W3F1-2022-0054

Subject: Revise Technical Specification 3/4.3.2 to Remove Exemption From Testing  
Certain Relays at Power to Support Elimination of Potential Single Point  
Vulnerability

Waterford Steam Electric Station, Unit 3  
NRC Docket No. 50-382  
Renewed Facility Operating License No. NPF-38

**Analysis of Proposed Technical Specification Change**

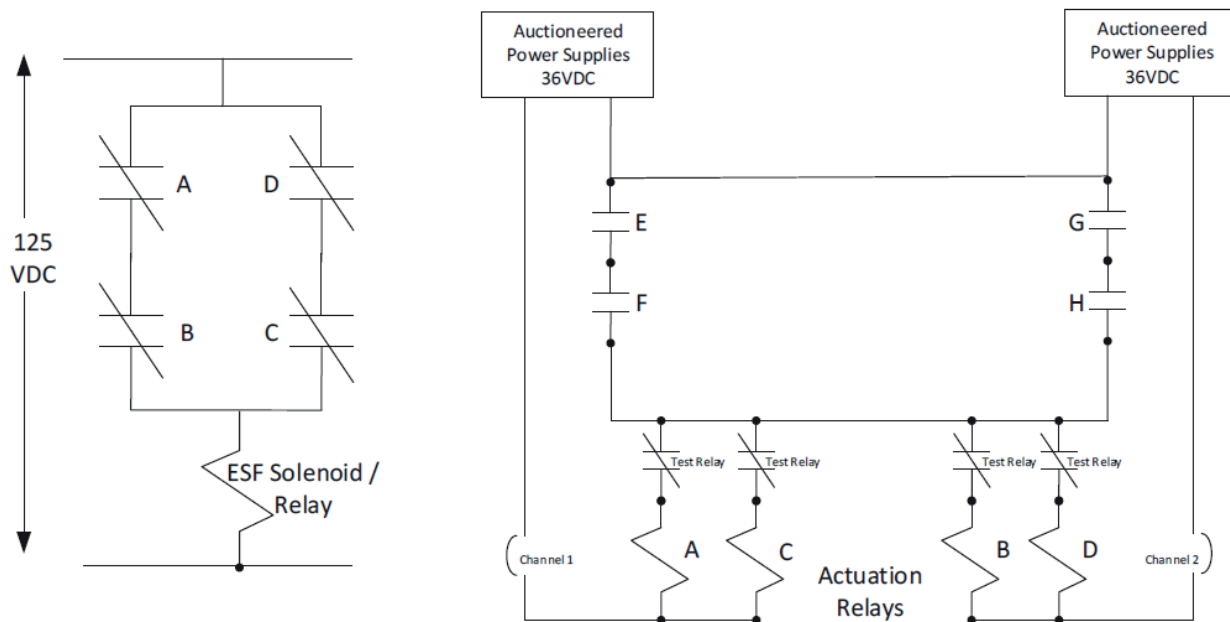
The following figure shows the simplified current configuration of the ESFAS SPV. This is a generic arrangement for explanation purposes. The specific relay changes will be shown in the next sections.

The ESFAS SPV is associated with the power supply arrangement. If a short circuit were to occur across the relay A coil, power would be lost to the left half of the ESF bus resulting in the deenergization of relays A and C. Such failures would not affect relays B and D as these have a separate negative and circuit breaker. Under this scenario, the ESF equipment associated with relay A would actuate. This is the SPV identified for the MSIS relays K305 and K313, and for the CSAS relay K114.

#### 4.2 Main Steam Isolation Signal Single Point Vulnerability Trip Hardening Modification

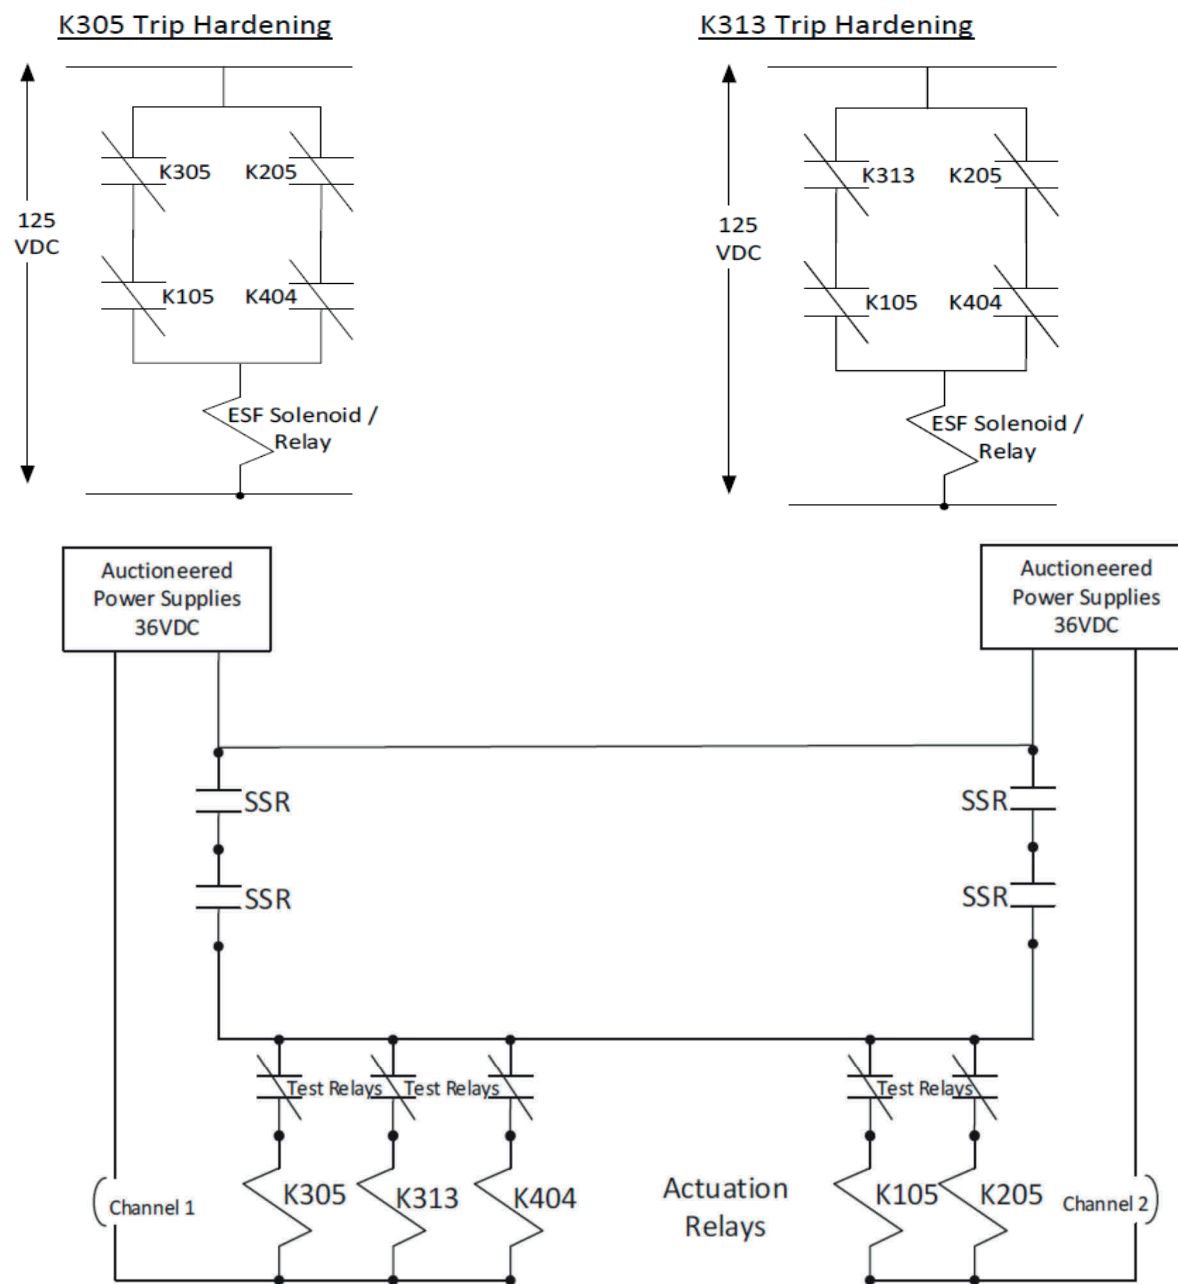
The K305 relay will be trip hardened by adding 3 additional relays creating a 2 out of 2 paralleled with 2 out of 2 logic scheme. The spare relays used to trip harden the K305 relay are relays K105, K205, and K404. Relays K305 and K404 are powered from one power supply while relays K105 and K205 are powered by a separate power supply. The K305 relay trip hardened contact is wired in series with the K105 relay contact. The K205 relay contact is wired in series with the K404 relay contact. Relays K305 and K105 or K205 and K404 are required to close to actuate the associated downstream ESF equipment.

The K313 relay will be trip hardened by adding 3 additional relays creating a 2 out of 2 paralleled with 2 out of 2 logic scheme. The spare relays used to trip harden the K313 relay are relays K105, K205, and K404. Relays K313 and K404 are powered from one power supply while relays K105 and K205 are powered by a separate power supply. The K313 relay trip hardened contact is wired in series with the K105 relay contact. The K205 relay contact is wired in series with the K404 relay contact. Relays K313 and K105 or K205 and K404 are required to close to actuate the associated downstream ESF equipment.

#### 4.3 Containment Spray Actuation Signal Single Point Vulnerability Trip Hardening Modification

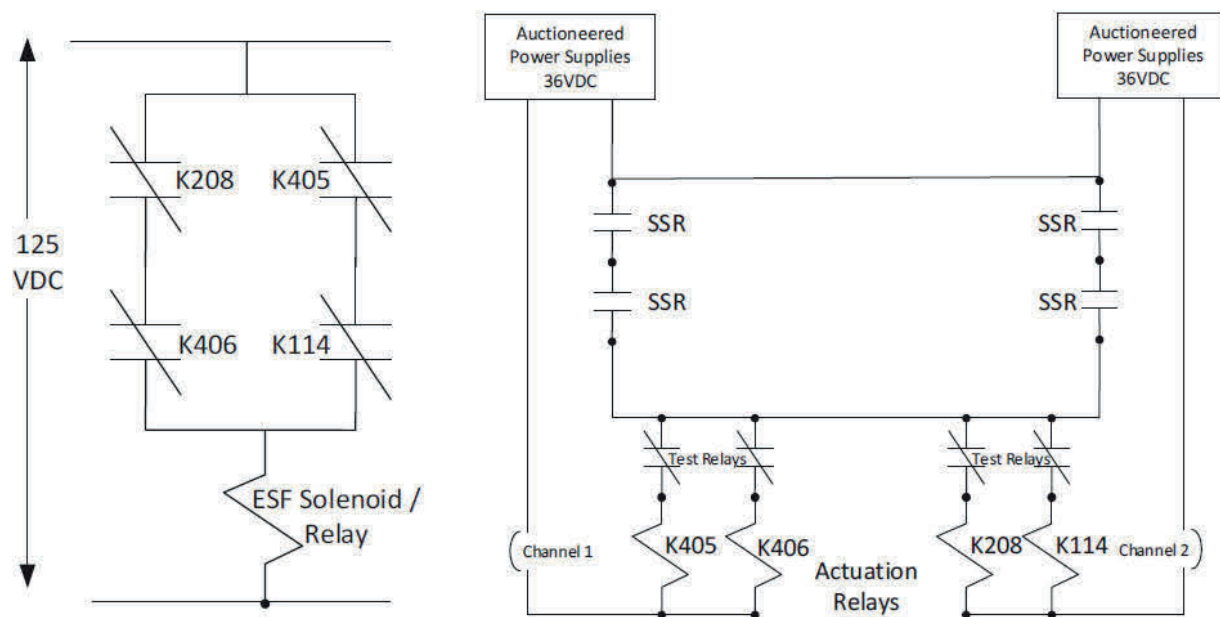
The K114 relay will be trip hardened by adding 3 additional relays creating a 2 out of 2 paralleled with 2 out of 2 logic scheme. The spare relays used to trip harden the K114 relay are relays K208, K405, and K406. Relays K114 and K208 are powered from one power supply while relays K405 and K406 are powered by a separate power supply. The relay K114 trip hardened contact is wired in series with the K405 relay contact. The K208 relay contact is wired in series with the K406 relay contact. Relays K114 and K405 or K208 and K406 are required to close to actuate the associated downstream ESF equipment.

## MSIS and CSAS Test Switch Arrangements

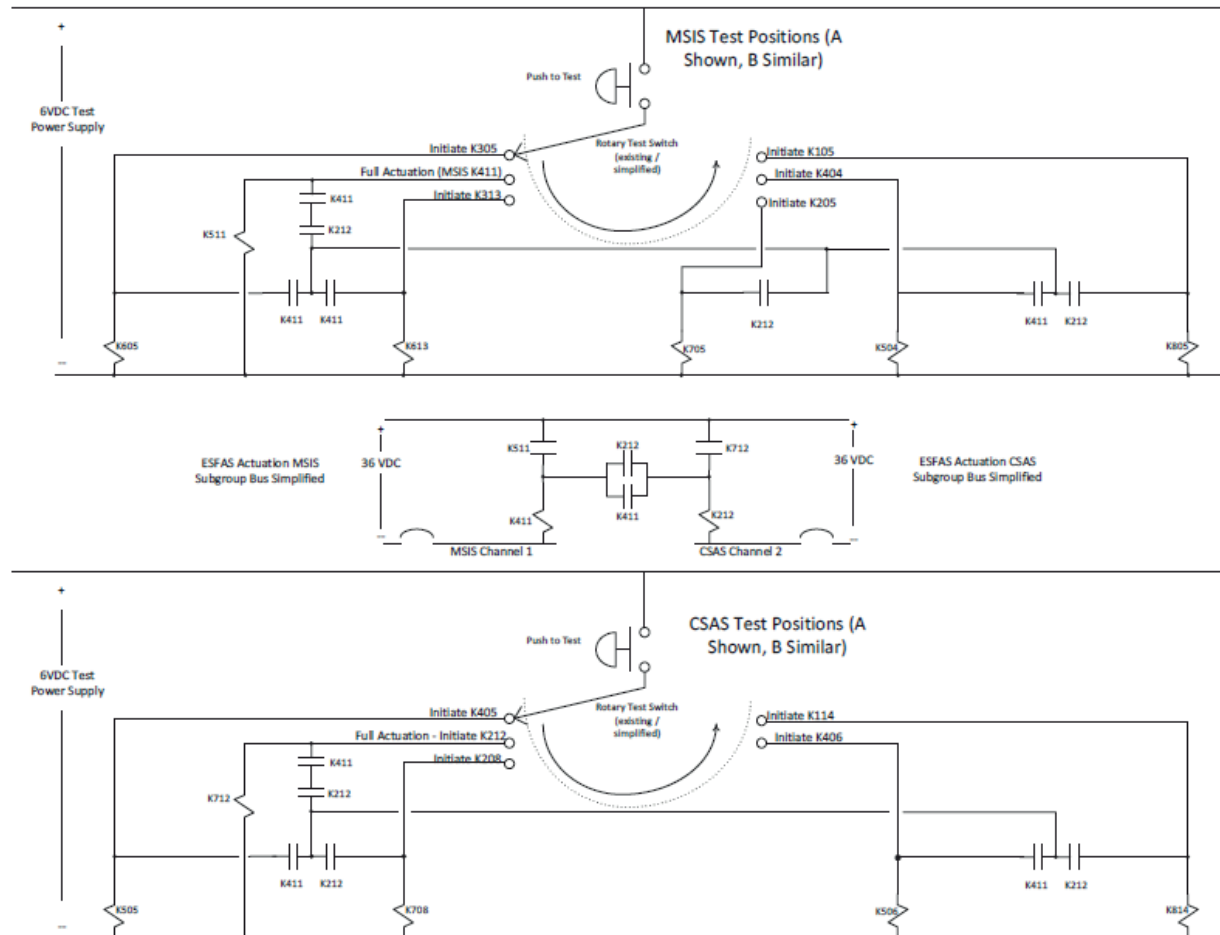
The gang operation of the MSIS and CSAS utilize two relays (K212 and K411) (formerly spare actuation relays) and associated test relays K511 and K712. The spare actuation relay contacts will be used to tie test actuation power to the test relays of the trip hardened relays allowing for simultaneous dropout of the trip hardened relays for the MSIS or CSAS. The gang operation is achieved using two existing spare relays and associated test relays including their pre-wired and pre-assigned test positions in the Control Room. Two relays are used to prevent introduction of an SPV if only one relay were used. The K212 and K411 relays provide the contacts and wiring to provide 6 vdc test power to all associated test relays for the trip hardened contacts of the MSIS and CSAS. The MSIS and CSAS test relay coil power is selected using the Control Room test switches and "Push to Test" pushbutton. Only the MSIS or CSAS can receive the test power at any given time due to exclusivity of the test switch. When aligned to relay K411, only test relays associated with the MSIS will receive the 6 vdc necessary to pick up test relays K605, K613, K705, K504, and K805. Power is provided through the test switch alignment and depressing the "Push to Test" pushbutton. Once the pushbutton is depressed, the 6 vdc source picks up test relay K511. Test relay K511 contact closes providing 36 vdc power to the MSIS subgroup relay K411. Relay K411 contacts close to provide the same 36 vdc source to K212. Contacts for K411 and K212 provide 6 vdc power source ties from the test switch to all test relays associated with the MSIS. The contacts which tie the coils of relays K411 and K212 together are utilized to maintain electrical separation when not in gang operation. The K411 and K212 relays are shared between the MSIS and CSAS. The 6 vdc power source is exclusive such that only power is available to the MSIS or CSAS when aligned.

During the Waterford 3 design review of the gang operation test circuit proposed for the ESFAS MSIS and CSAS, it was identified that the potential existed to create test equipment sneak circuits if gang relay (K411 or K212) contact(s) were to become stuck closed. These stuck contact(s) induced sneak circuits that could result in unexpected equipment actuation during online subgroup relay testing. Even though such gang relay contact failures are fully detectable by discrete (offline) subgroup relay testing, it was decided to even further harden the test circuits against the likelihood of these detectable gang relay contact failures. Refer to the June 29, 2018 LAR supplement (Reference 3) for details regarding the design change to improve "hardening" against the potential stuck contact(s) induced sneak circuit. A discussion of the design hardening improvements to prevent a full actuation of the MSIS or CSAS for the scenarios involving a single stuck gang relay contact (K411 or K212) and a stuck gang relay (all contacts for K411 or K212 closed) is presented in Section 4.7 of this Enclosure.

The next figures are simplified versions of the test switch arrangement and the gang operation of the MSIS and CSAS incorporating the improved test circuit hardening design.

### 4.6 Light Emitting Diode Relay Light Indication

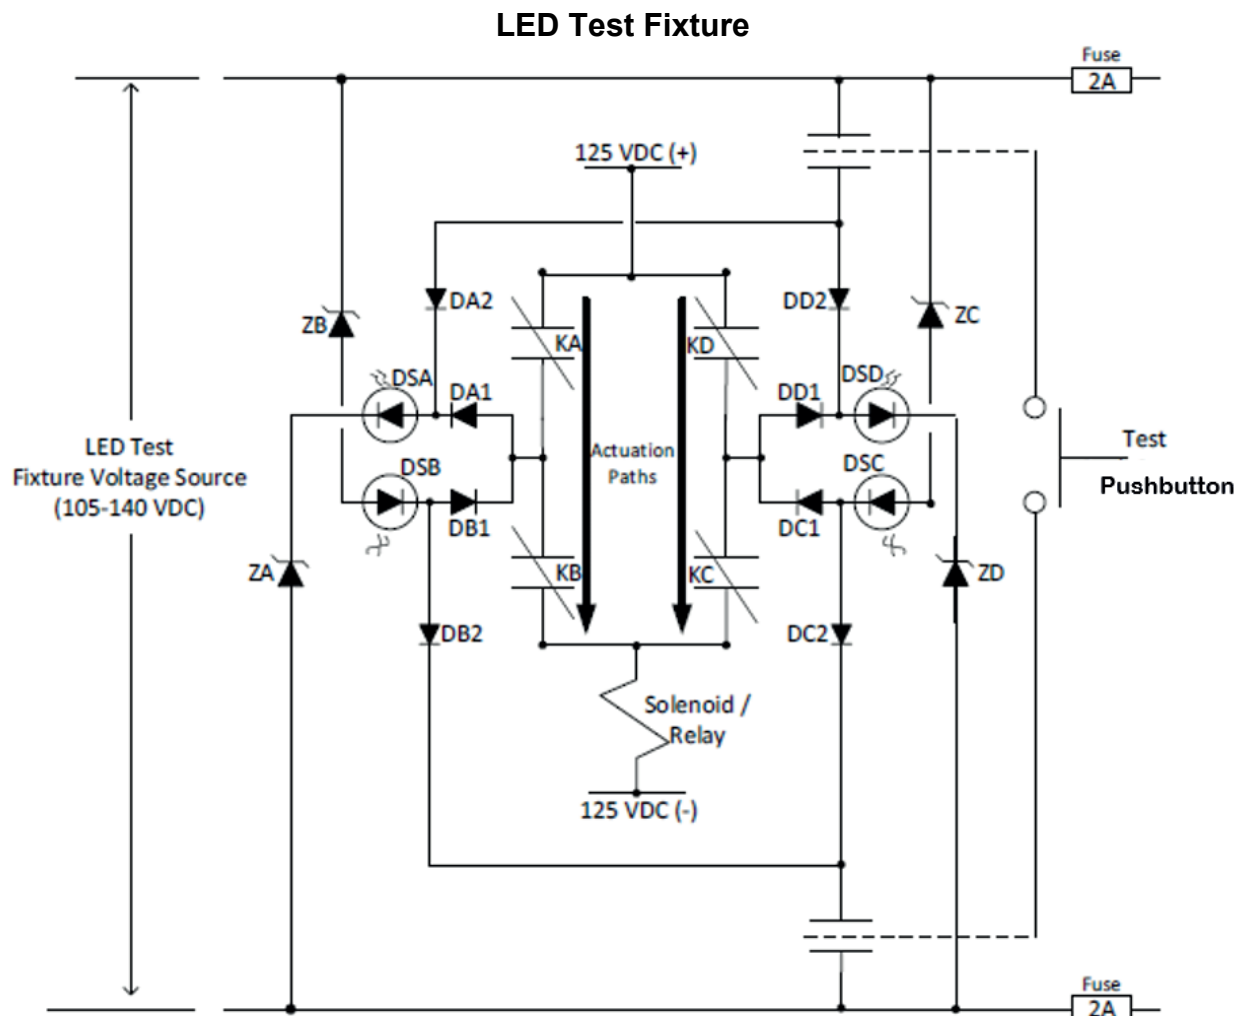
The ESFAS SPV trip hardening modification includes new Light Emitting Diode (LED) Test Fixtures that will be installed in the ESFAS Train A and B cabinets. The LED Test Fixtures provide light indications of trip hardened contact closures during testing and are also used during normal operating rounds to verify that the trip hardened relays have not failed. A "Test Pushbutton" is provided for lamp checks during operator rounds to verify all LEDs are in working order.

The next figure is a simplified diagram of the LED Test Fixture (the Train A and B LED Test Fixtures are virtually identical). KA through KD are the subgroup actuation relay contacts. DSA through DSD are the LEDs used to monitor their respective actuation contact. The following examples assume all contacts are open unless stated otherwise. As an example, assume Operations is performing an online surveillance test of each relay (KA, KB, KC, KD) discretely, meaning only one is being tested at a time. The first step Operations will perform is verifying the LEDs are working properly by depressing the "Test Pushbutton." Once all LEDs are verified illuminated, the pushbutton will be released, extinguishing the LEDs. Next, Operations will verify no LEDs remain illuminated (which would indicate a failed actuation relay or contact). Once all LEDs are verified extinguished, testing may be performed. Assume KA is under test. Contact KA is monitored by LED DSA. When KA is closed, DSA is illuminated (ON). When KA is open, DSA is not illuminated (OFF). The remaining LEDs (DSB through DSD) function in the same manner.

#### 4.7 Design Hardening Improvement to Prevent Voltage Sneak Paths

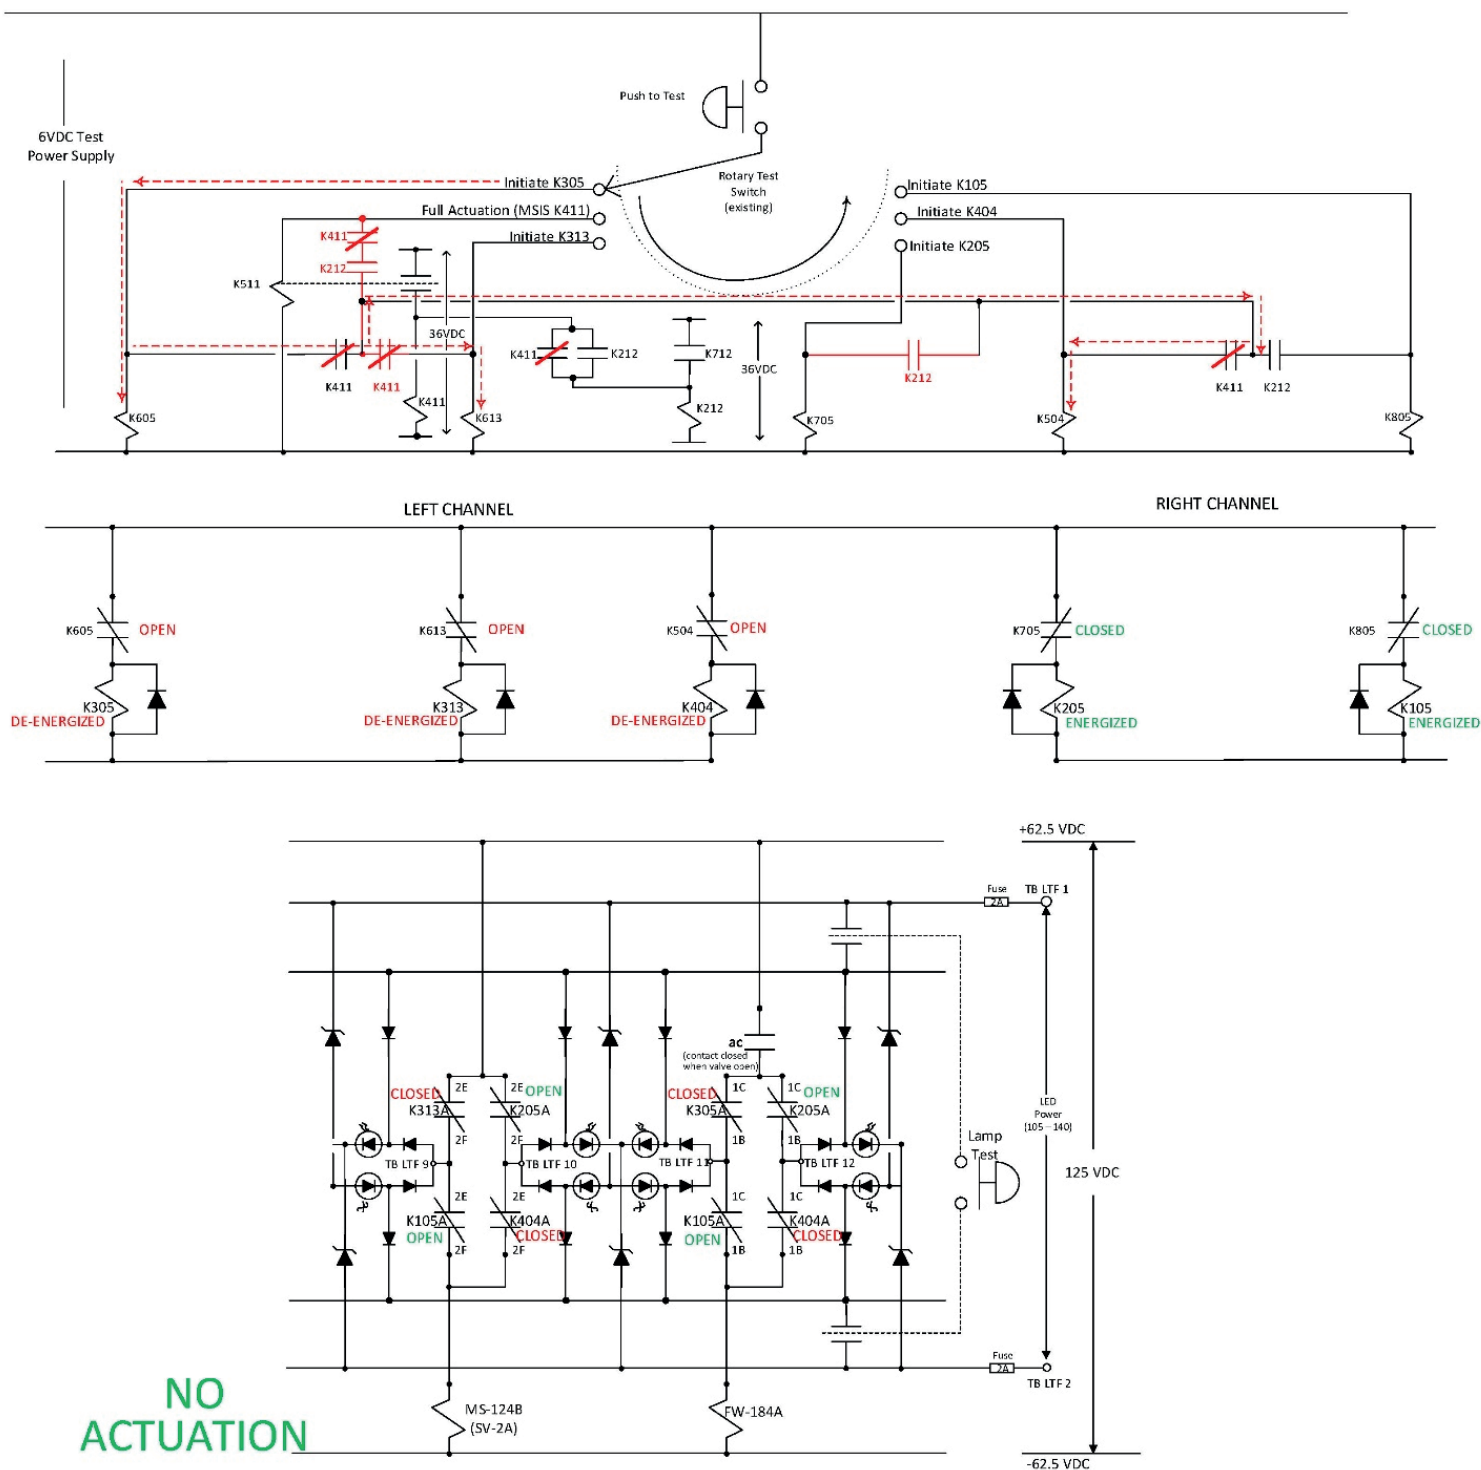
The following figures depict the design which has been "hardened" against the voltage sneak paths described in Section 4.5 of the Enclosure. The addition of the K411 and K212 contacts in the improved hardening design block the voltage from the K511 coil during discrete subgroup relay testing, thus preventing full actuation of the MSIS or CSAS under the condition of a single stuck gang relay contact (K411 or K212) scenario. The ESFAS MSIS and CSAS test circuits are also hardened for channel protection such that a stuck gang relay (all contacts for K411 or K212 closed) would not result in full actuation of the MSIS or CSAS. The "left channel" is arranged with K411 contacts and the "right channel" is arranged with K212 contacts. In the scenario depicted in the following figures, if all the gang relay K411 contacts are stuck closed, a full actuation would not occur. The only result would be that the left channel subgroup relays actuate (K212 results are similar for right channel only). Full actuation requires that both the left and right channel subgroup relays actuate. For the condition described, the actuation of all the left or right channel relays would be detected by the LED Test Fixture indication. In the described scenario, two LED lights will illuminate. If the circuit were operating properly and there are no stuck gang operated test relay contacts, only a single LED out of 4 per group for a given valve would illuminate.

**SCENARIO: All K411 (shown) or K212 contacts are stuck closed after a full actuation**
